Addendum to the Visual Impact Assessment (October 2015)

Centennial Corridor Project

Project ID: 0600000484
SCH ID: 2008091102

PURPOSE OF THE TECHNICAL MEMORANDUM

Attachment 1
Kaiser Realignment

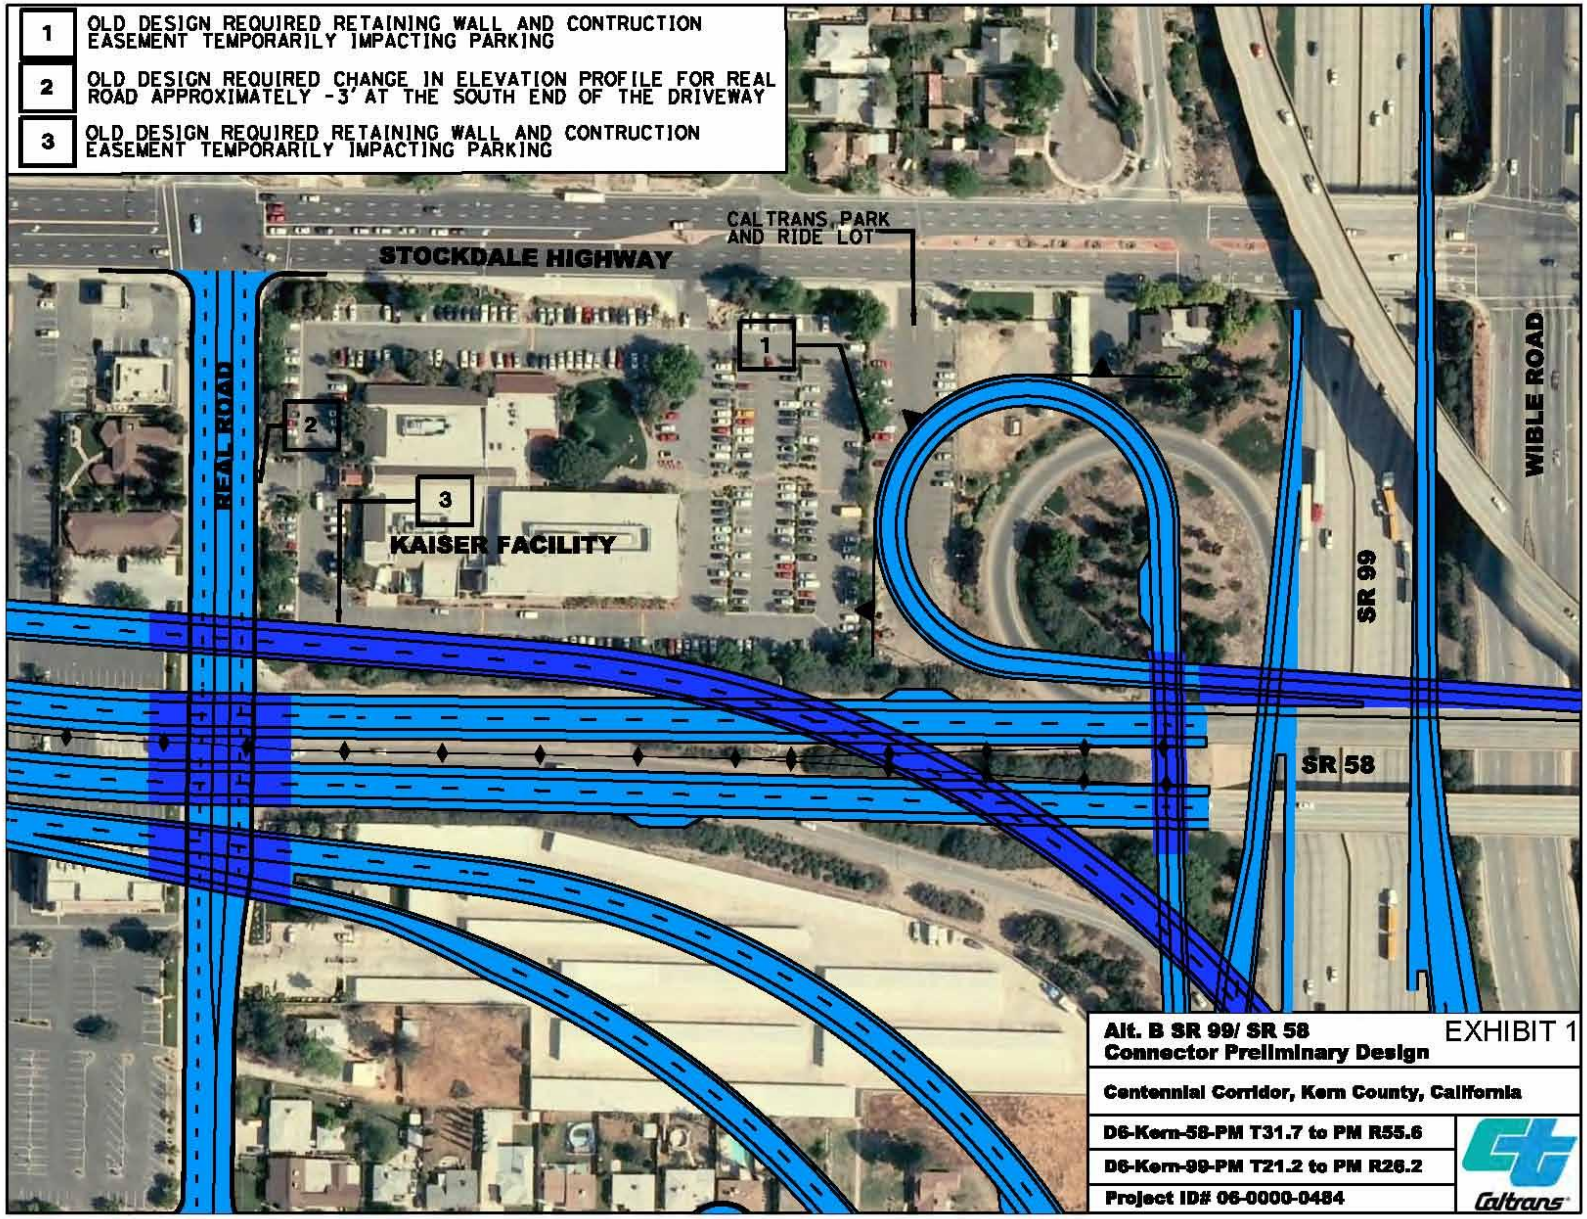
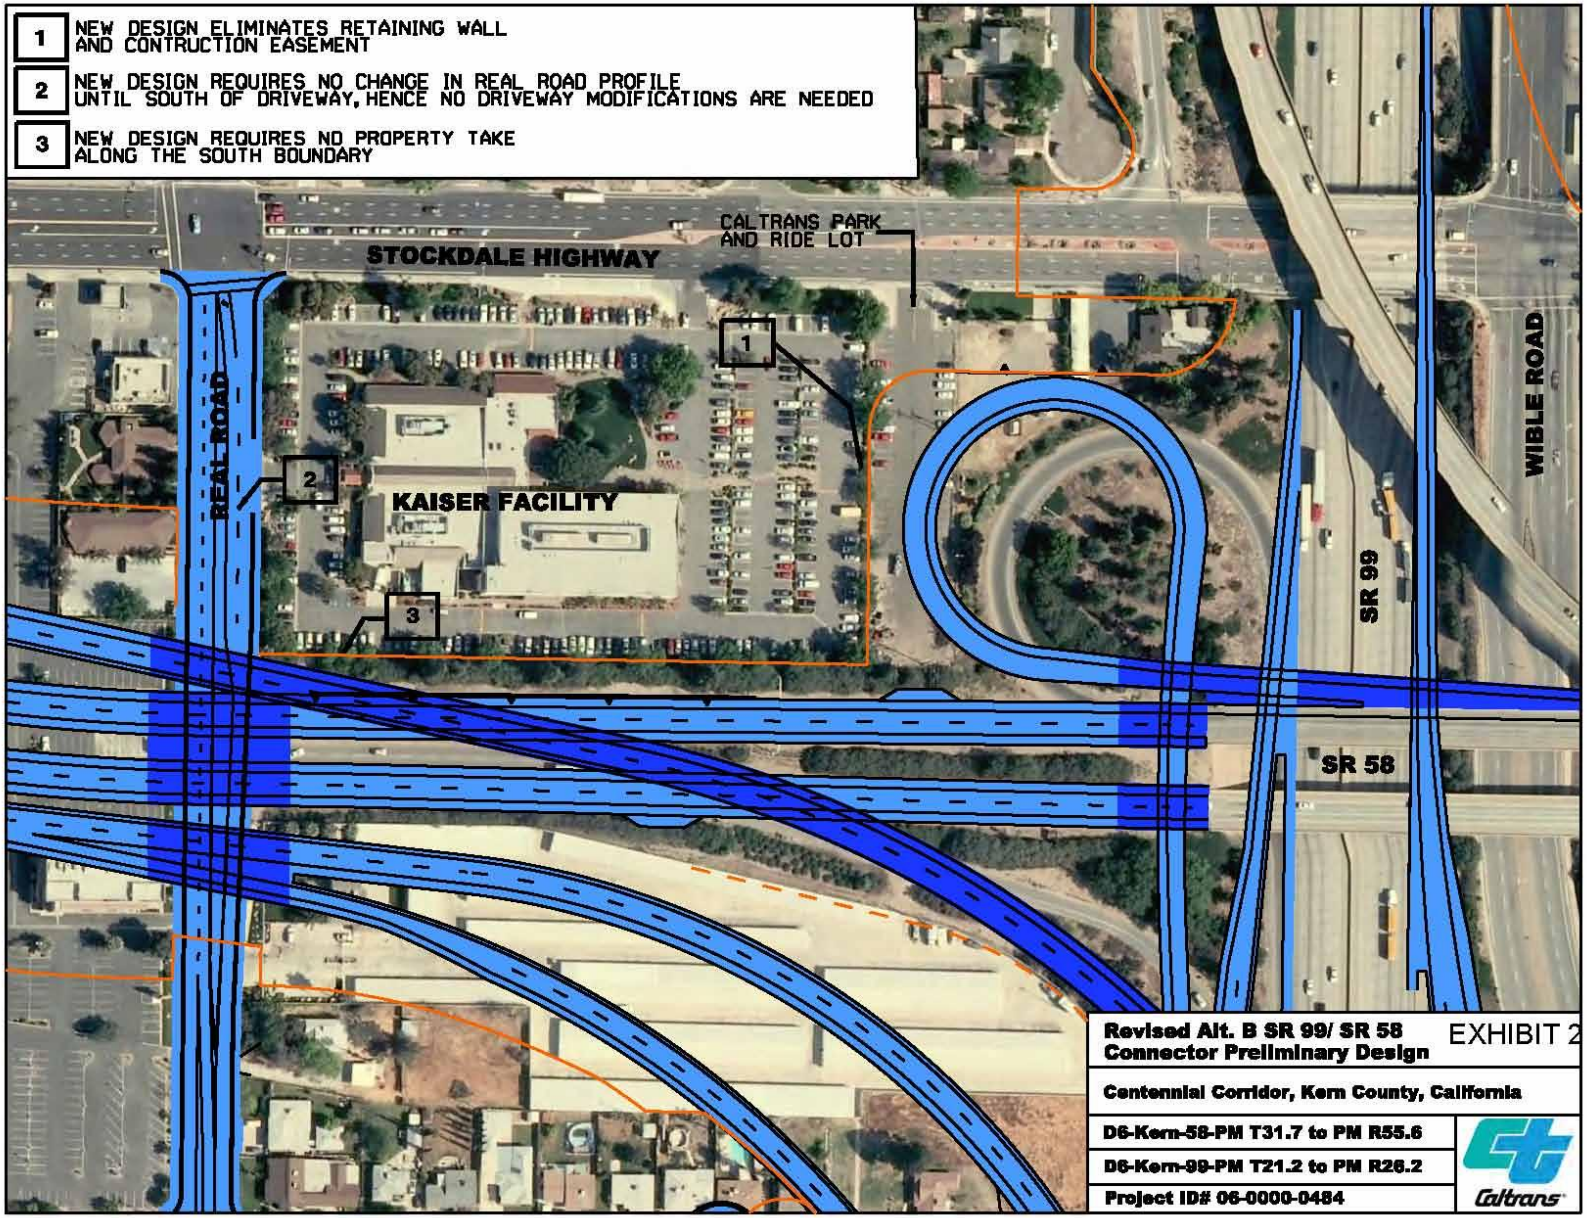
During the public circulation period of the draft environmental document, Caltrans and the city of Bakersfield received a letter on behalf of Kaiser Foundation Health Plan, Inc. (Kaiser), dated July 7, 2014, describing various concerns in regard to the proposed Centennial Corridor Project. Due to these concerns, preliminary design plans for Alternative B were modified to avoid direct impacts to the Kaiser Health Care Center. The preliminary design revisions that would avoid impacts on the Kaiser medical offices are depicted in Attachment 1 of this Addendum. These revisions would significantly increase the distances between the Kaiser facility and the project improvements, creating an 80-foot buffer between the medical facility's parking lot and the proposed alignment. No obstructions associated with the Centennial Corridor Project will block Kaiser Health Care Center driveways, and no modifications would be made to change the configuration of the existing driveways. In addition, the modified design will not require property or temporary construction easements on Kaiser's property.

1 OLD DESIGN REQUIRED RETAINING WALL AND CONTRUCTION EASEMENT TEMPORARILY IMPACTING PARKING
2 OLD DESIGN REQUIRED CHANGE IN ELEVATION PROFILE FOR REAL ROAD APPROXIMATELY -3' AT THE SOUTH END OF THE DRIVEWAY
3 OLD DESIGN REQUIRED RETAINING WALL AND CONTRUCTION EASEMENT TEMPORARILY IMPACTING PARKING
CALTRANS PARK AND RIDE LOT
STOCKDALE HIGHWAY
REAL ROAD
KAISER FACILITY
SR 99
SR 58
WIBLE ROAD
Alt. B SR 99/ SR 58 Connector Preliminary Design
EXHIBIT 1
Centennial Corridor, Kern County, California
D6-Kern-58-PM T31.7 to PM R55.6
D6-Kern-99-PM T21.2 to PM R26.2
Project ID# 06-0000-0484
Caltrans

1 NEW DESIGN ELIMINATES RETAINING WALL AND CONTRUCTION EASEMENT
2 NEW DESIGN REQUIRES NO CHANGE IN REAL ROAD PROFILE UNTIL SOUTH OF DRIVEWAY, HENCE NO DRIVEWAY MODIFICATIONS ARE NEEDED
3 NEW DESIGN REQUIRES NO PROPERTY TAKE ALONG THE SOUTH BOUNDARY
CALTRANS PARK AND RIDE LOT
STOCKDALE HIGHWAY
REAL ROAD
KAISER FACILITY
SR 99
SR 58
WIBLE ROAD
Revised Alt. B SR 99/ SR 58 Connector Preliminary Design
EXHIBIT 2
Centennial Corridor, Kern County, California
D6-Kern-58-PM T31.7 to PM R55.6
D6-Kern-99-PM T21.2 to PM R26.2
Project ID# 06-0000-0484
Caltrans

Attachment 2
Carrier Canal Crossing Design Modification

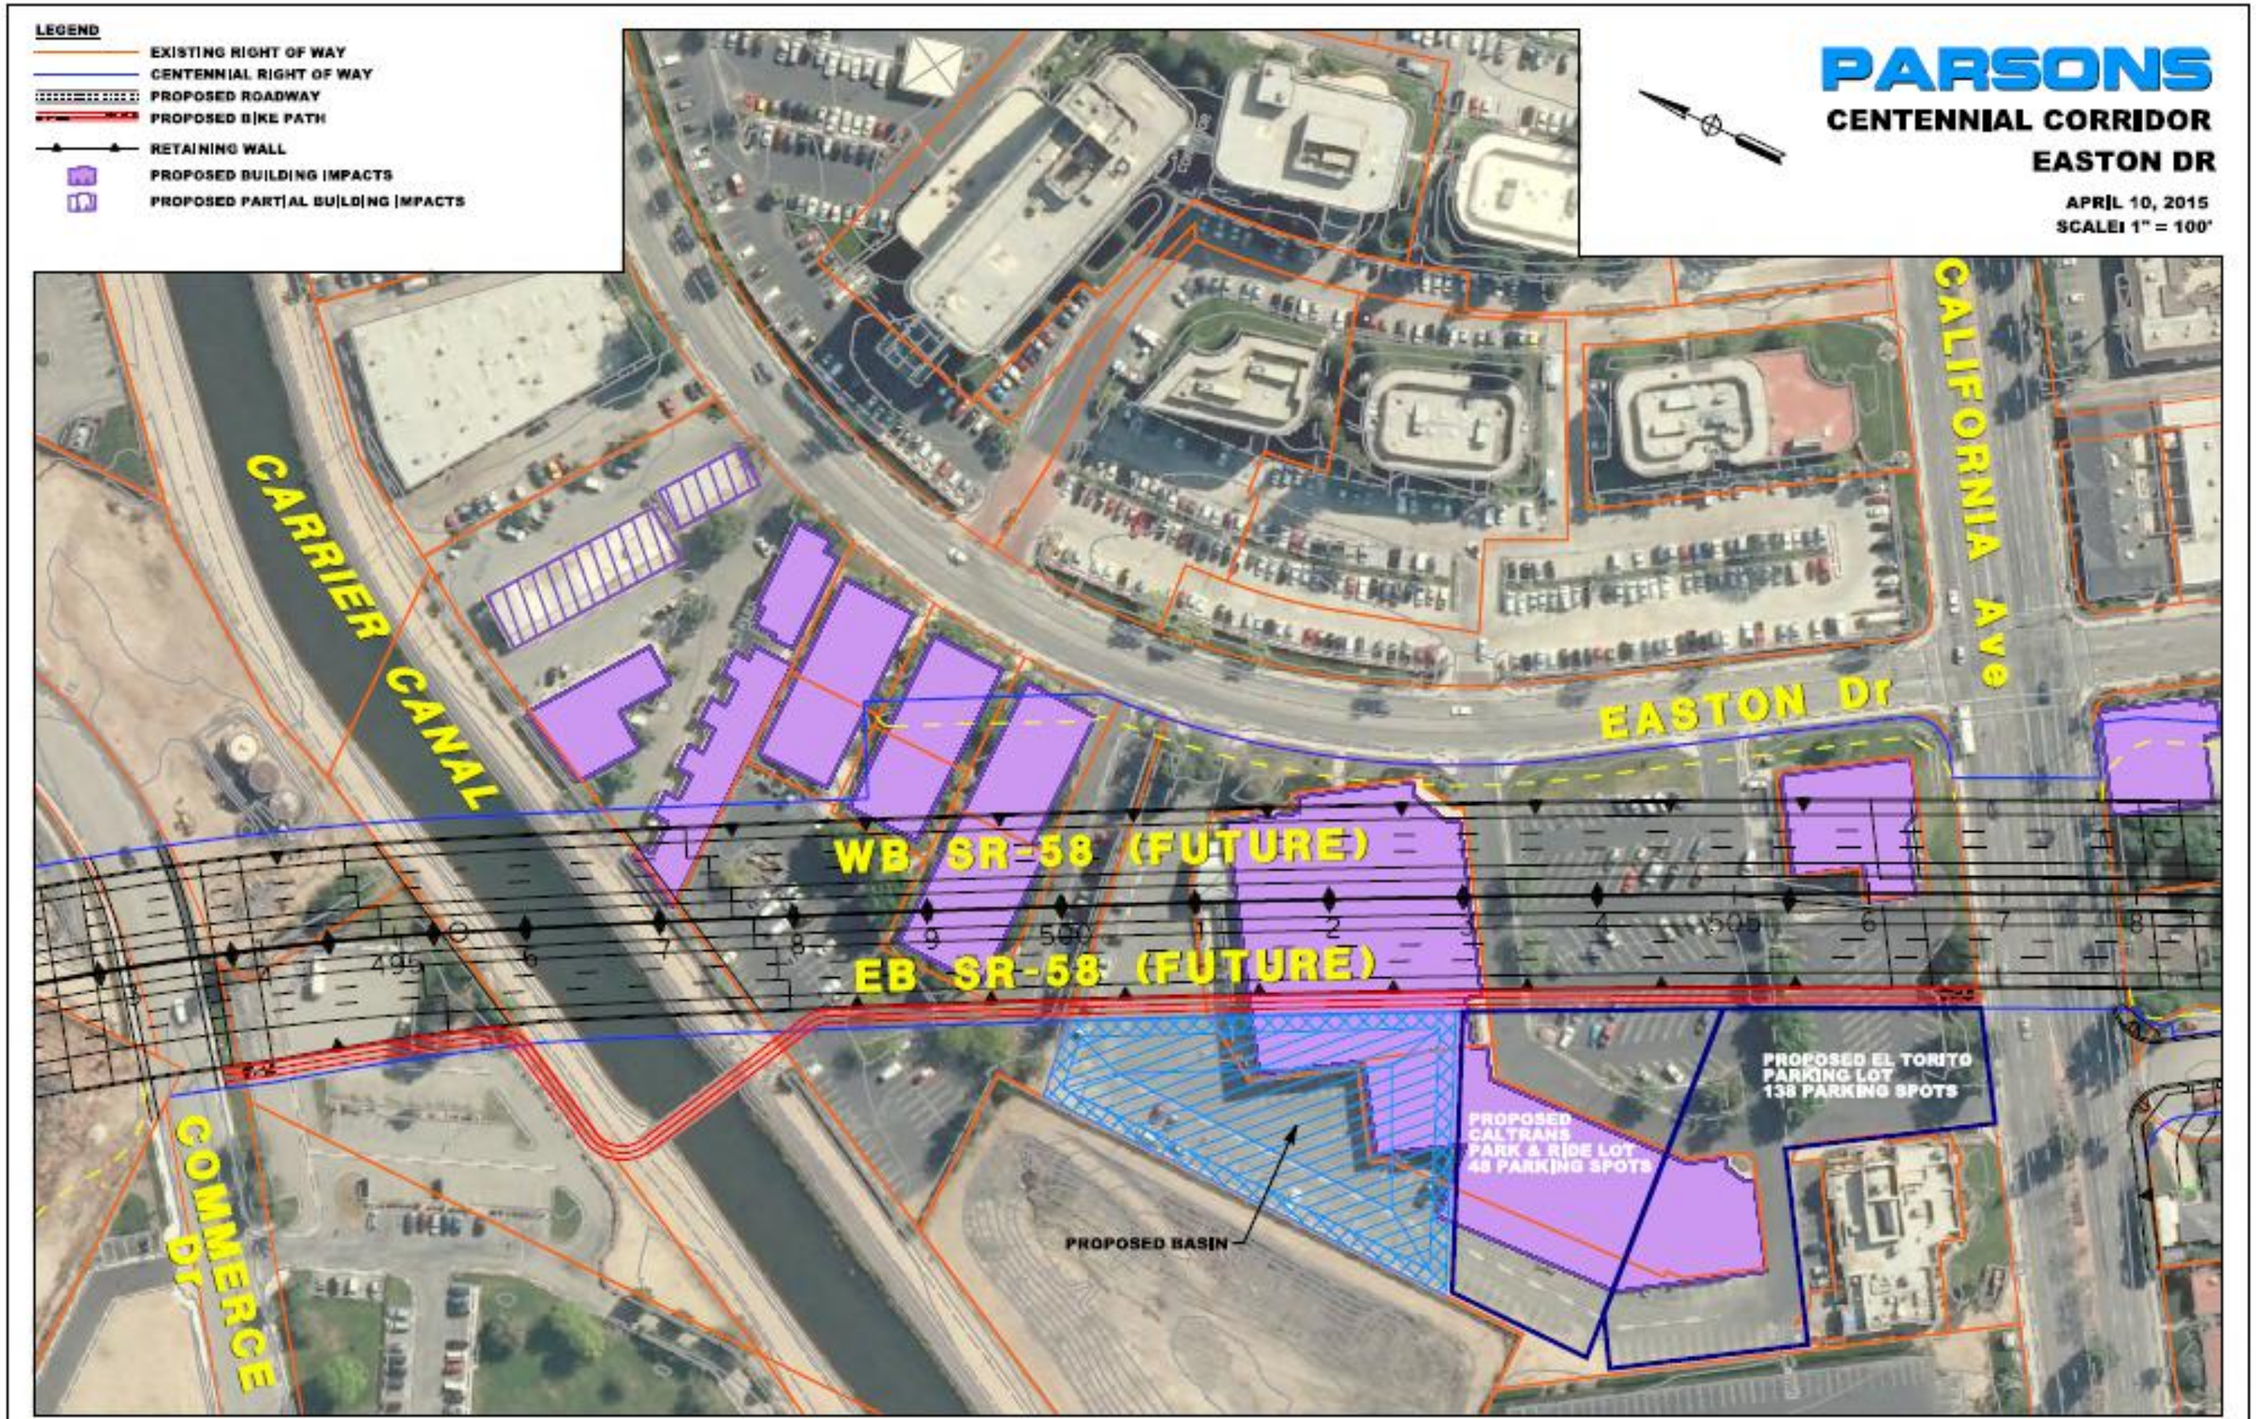
To address concerns regarding bicycle and pedestrian connectivity, preliminary design plans for Alternative B were revised to include a multi-use pathway that will run parallel to the project alignment connecting bicyclists and pedestrians from California Avenue to Commerce Drive. The decision to incorporate a multi-use pathway to accommodate a bicycle and pedestrian connection was made in response to public comments requesting a bicycle connection spanning over the Carrier Canal. As part of this change, an approximately 100-foot-long-bridge over the Carrier Canal would be constructed to accommodate bicycles and pedestrians. The bridge would be of sufficient width to accommodate two-way pedestrian and bicycle traffic. The preliminary design layout for the Carrier Canal Crossing is included in Attachment 2 of this Addendum. The proposed modification is located within the study area analyzed in the draft environmental document and supporting technical studies. This multi-use pathway and bridge structure will provide direct connectivity to the Kern River Parkway Bike Trail for its users.

Attachment 3
Joseph Drive Pedestrian Crossing

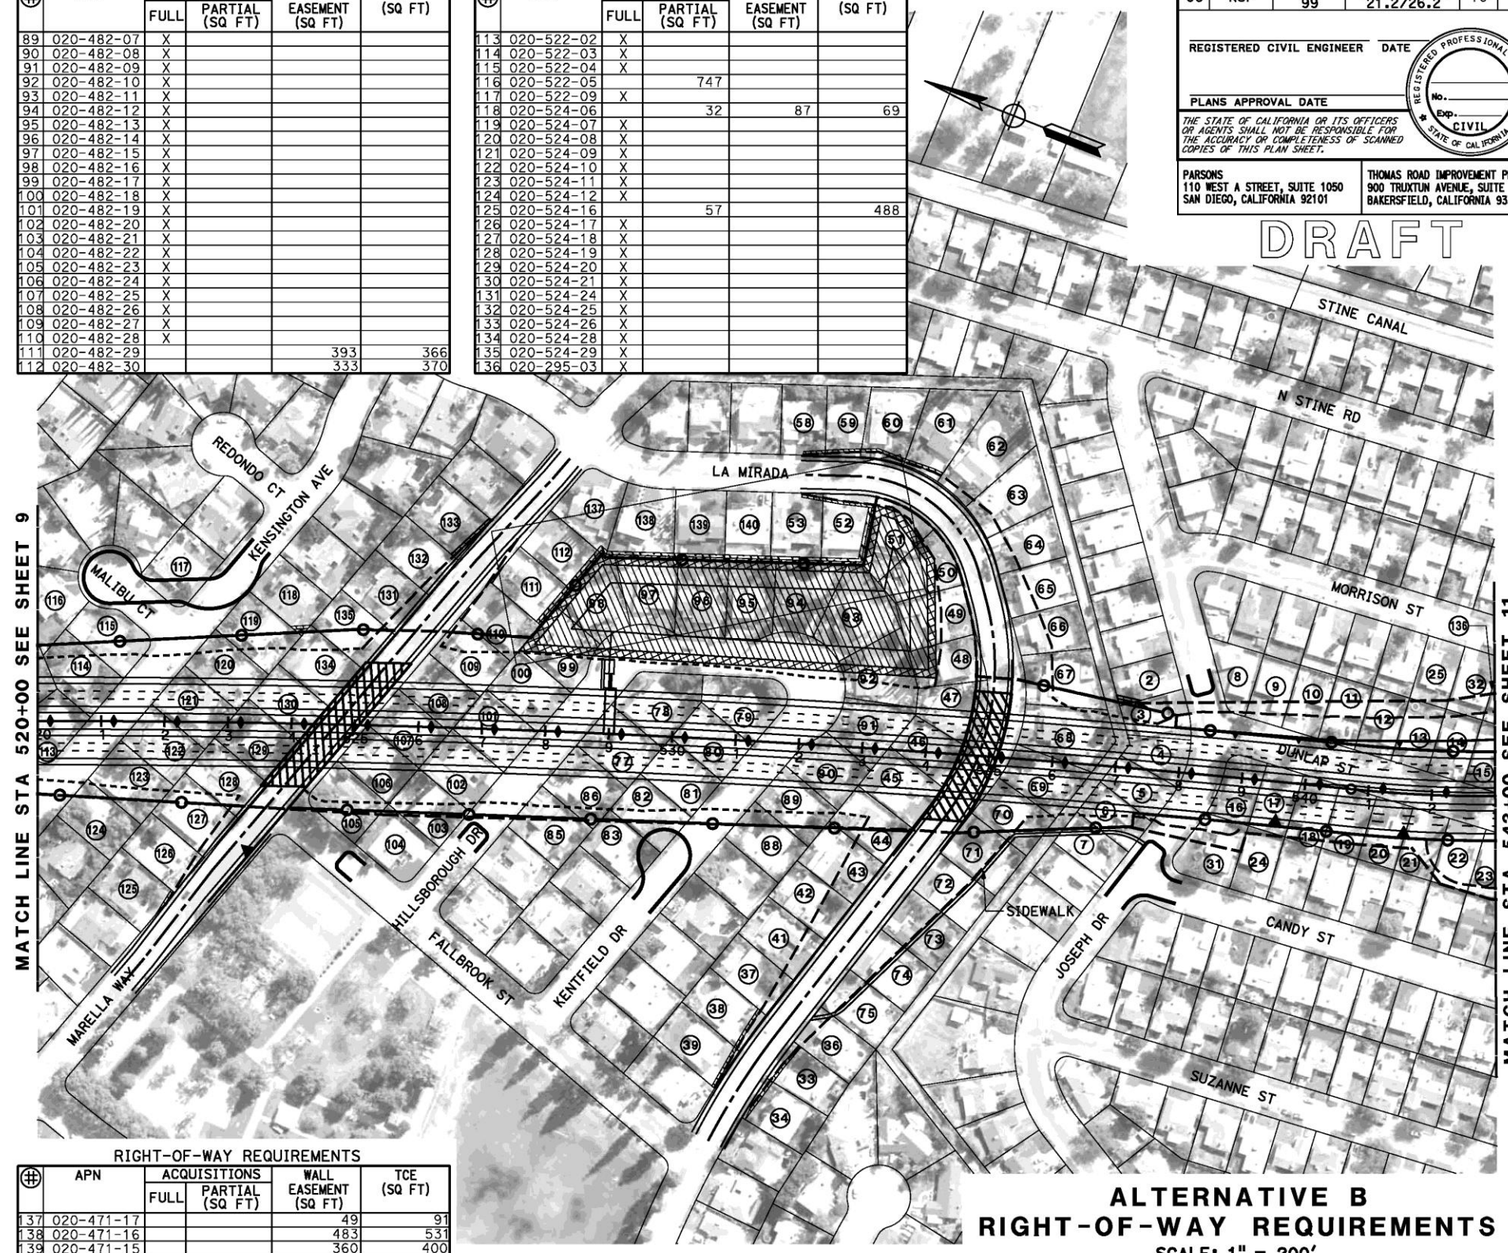
Implementation of the Centennial Corridor Project will result in the permanent closure of 11 local streets, which in some cases greatly lengthens the routes for current pedestrian routes in the Westpark neighborhood. The city will coordinate with Caltrans to install a dedicated new pedestrian sidewalk for the benefit of residents living in homes south of La Mirada Drive and Joseph Drive. The pedestrian sidewalk would enhance connectivity to newly divided areas in the Westpark neighborhood and shorten the route for pedestrians to access popular community facilities located on either side of the freeway, including Centennial Park, Harris Elementary school, and other neighborhood destinations. This proposed feature would upgrade bicyclist and pedestrian access via La Mirada Drive. The preliminary design layout for the Joseph Drive pedestrian crosswalk is included in Attachment 3 of this Addendum.
